SERVICING INFORMATION ADDENDUM

MODEL 3011B FUNCTION GENERATOR

PORTION OF SCHEMATIC DIAGRAM CHANGED:

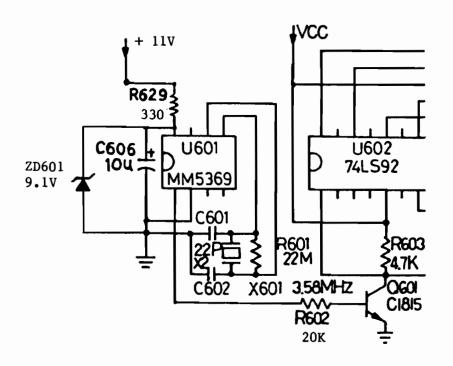
Effective with serial no. 147-30253, Model 3011B has been factory modified to add ZD601 and change the values of R602 and R629. Use the schematic diagram and parts list information in this addendum for servicing units after serial no. 147-30253.

R602	$20 \text{ k}\Omega \pm 5\%$, 1/4 W carbon film resistor	002-104-5-203
R629	3300 ± 5% 1/4 W carbon film resistor	002-104-5-331
ZD60	01 9.1 V. 500 mW Zener Diode	152-207-9-001
